Our Ref: J-2799-02 Date: 19 April 2023

Change of Use of Part Ground and First Floor Commercial Space With Second Floor Extension to Create Two Residential Units (Retaining Existing Ground Floor Street Frontage Commercial Area) Including Partial Demolition of Rear Part of Building. The Isles Of Scilly Steamship Company, Hugh Street, Hugh Town, St Mary's, Isles Of Scilly, TR21 0LJ

Planning Ref: P/22/085/COU Steamship House

Addendum to Flood Risk Assessment

Figure 1 Plan Showing Potential Tidal Flood Routes to the Site

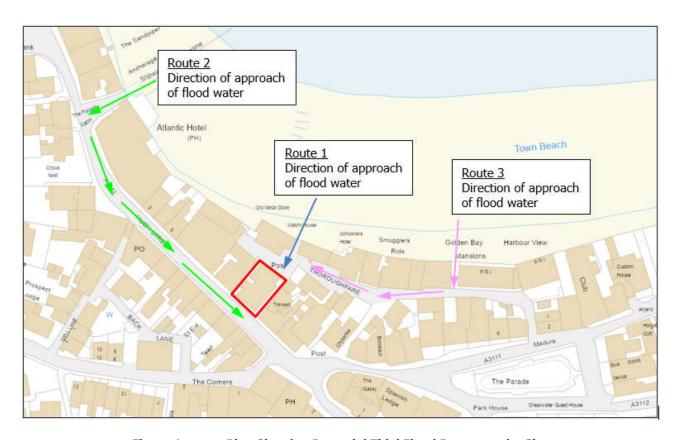
Concern is expressed within the correspondence received that insufficient consideration has been given to the action of flood defenses and their interaction with surface water runoff/flooding.

In this context, when considering ground levels and LIDAR data provided, it is evident that sea water will initially approach the site from St Mary's Harbour via the alleyway which runs between the buildings backing onto the harbour beach, specifically between the Old Metal Store and the Watch House; see Route 1 on **Figure 1** below.

Notwithstanding the presence or otherwise of flood defences along Route 1, there are other inundation routes to the site that are able to bypass this alley way. In this regard there is a route from the harbour up the slipway to the side of Atlantic Hotel; see Route 2 on **Figure 1** and **Photo 2** below. Ground levels on the road at the top of the slipway are set at approximately 3.75m AOD. Once the surface of the seawater reaches this level, water is able to move along Hugh Street towards the site as the road is essentially flat or lower than this level. Water can then run down the alleyway at the side of the building to the accommodation behind.

There is also a third potential route off the beach through the alley way to the immediate east of Golden Bay Mansions; see Route 3 on **Figure 1** and **Photo 3** below.

Figure 4 Extract from EA Long Term Flood Risk Map for Low-Risk Scenario

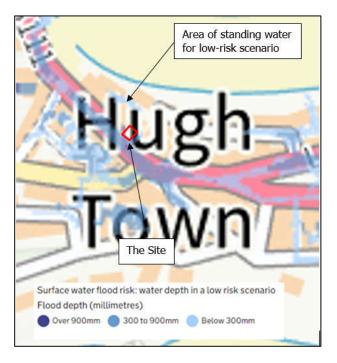
Responses received from the FRA call for more information to be provided on surface water drainage proposals and for the implications on tidal lock on drainage outlets to be considered. In this regard it is noted that the proposed development will not increase the area of impermeable surfacing on site and that it is intended to retain the existing surface water drainage provisions as there is no need to alter these arrangements.

Some standing water is shown to exist to the rear of the building (depth 300mm or less) for the low-risk scenario (see **Figure 4** below), but no flooding is shown to occur for either the high or medium risk scenarios. The low-risk event has a probability of occurring between 0.1% and 1% each year (1 in 1000 year to 1 in 100 year).

The probability of this event occurring coincident with the peak of a 1 in 200-year tide over a window of some 4 hours is considered to be minimal.

ADDENIDTY D	DEVICED	I AVALIT EAD	TRITEDRIAL	ACCOMMODATIO	1 1 1
APPENIII A B	K C V I SCII	I AYUNIN FUR	INICKINAL		114

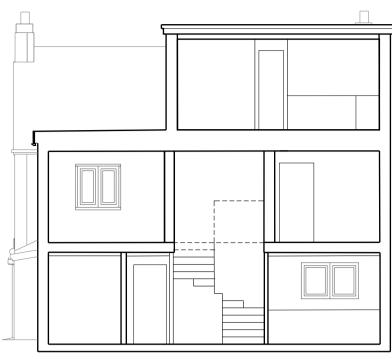
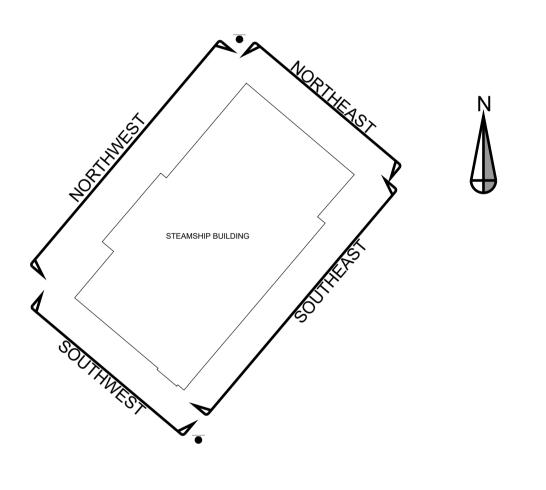
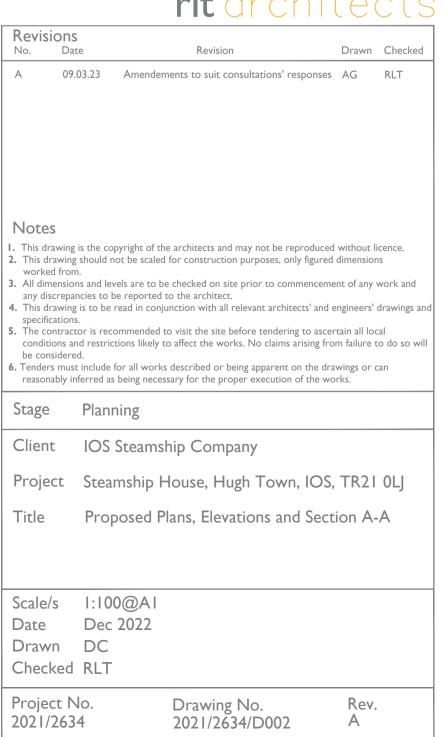
Concern has been expressed that no internal escape route has been identified for residents of the ground floor accommodation (Flat 3) in the event of a flood. There is also sleeping accommodation proposed on the ground floor in the case of Flat 3, which was not preferred on flood risk grounds.

This concern has been recognised and the proposed accommodation has been reconfigured accordingly. To this end the sleeping accommodation within Flat 3 has been moved to the first floor of the building. In addition an internal stairway has been provided within the flat to link the ground floor of Flat 3 with the first-floor accommodation. A revised layout for the proposed accommodation is provided within **Annex 2**.
